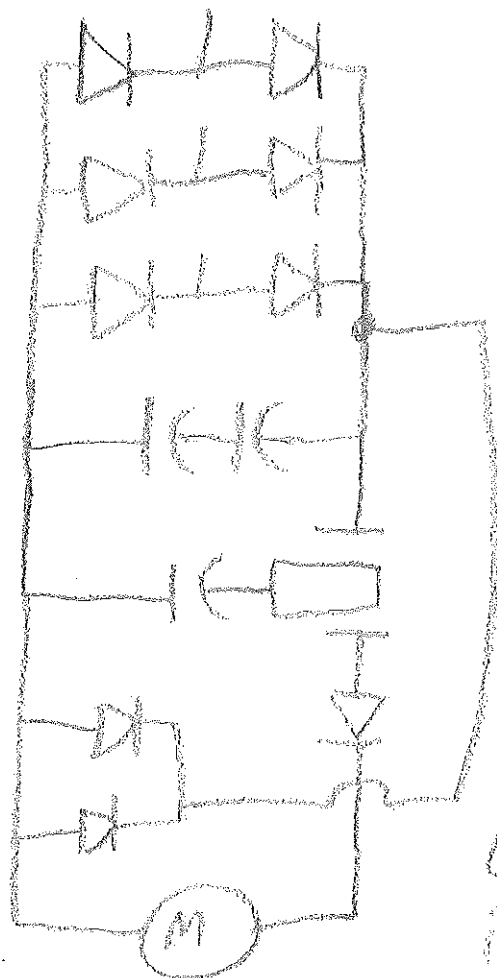
2 alternator
capacitors
in series

Removed
line diode between
capacitor & switch

Back EMF to
alternator capacitors
instead of
switch capacitors
